PRE-APPLICATION CONFERENCE NOTES

Magnum Power (PLZ-22-0147)

SITE PLAN

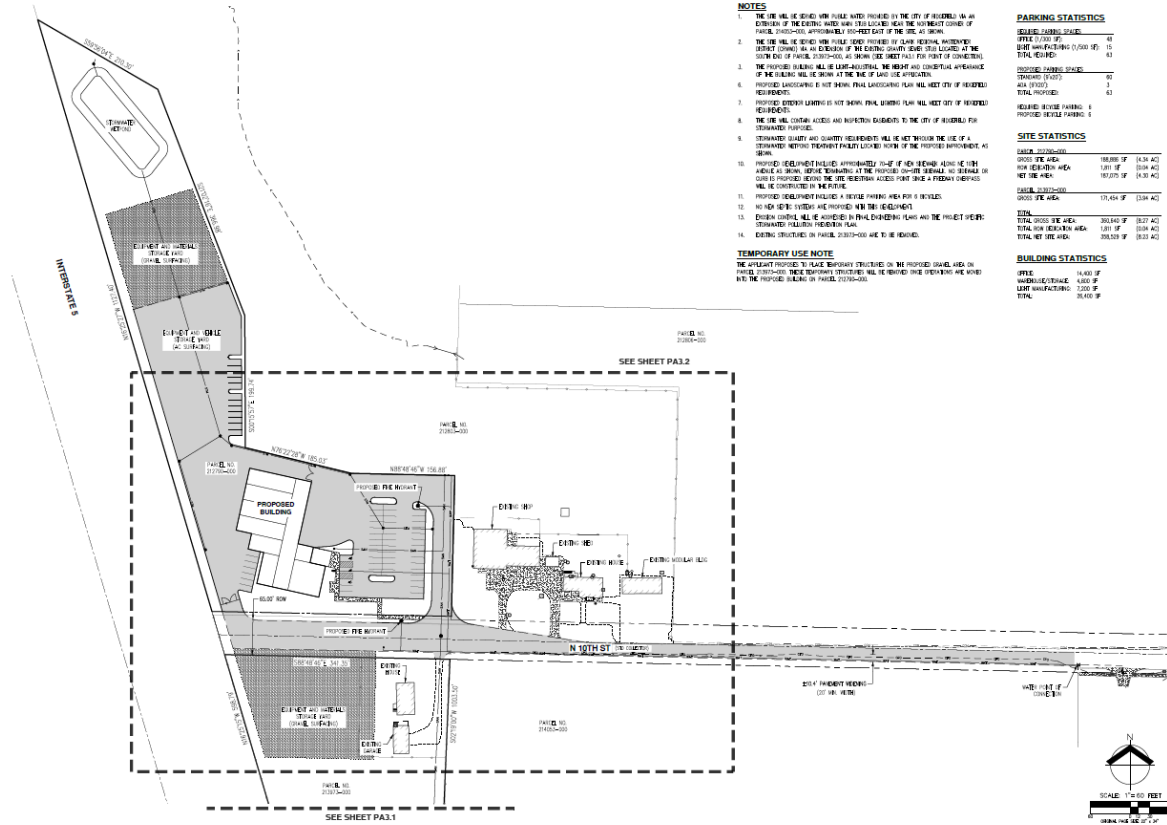
Comment: A lot combination and/or a boundary line adjustment may need to be completed concurrently with the site plan review. The current lot configuration does not match the preliminary plan.

Total parking stalls required, per the above calculations is 66 stalls. The applicant lists 63 stalls on the proposed plan. Additional parking will need to be provided to comply with regulations. For 66 stalls, 3 ADA parking stalls will be required, one of which will need to be van accessible. 3 ADA stalls show on the proposed plans.

Pedestrian access corridors must link all parking areas to a primary building entrance via the most practicable route and separate pedestrians safely from motor vehicle traffic. Site configurations in the E zone shall avoid creating entrapment areas such as dead-end pathways where a pedestrian could be trapped by an aggressor. The applicant will need to provide safe walking routes from the parking at the center of the site, from the east parking area and the parking area located north of the building.

One bicycle parking space is required for every twelve required car parking stalls. The applicant shows 6 bicycle parking spaces which complies. Walking paths need to be installed from the building to the street sidewalk.

Access aisles shall have a minimum width of twelve feet (one-way) and twenty-four (two-way) to ensure adequate vehicular turning and maneuvering. For technically complete, a plan must be shown that meets the minimum twenty-four-foot requirement for two-way traffic or identifies the access aisle as limited to one-way traffic.
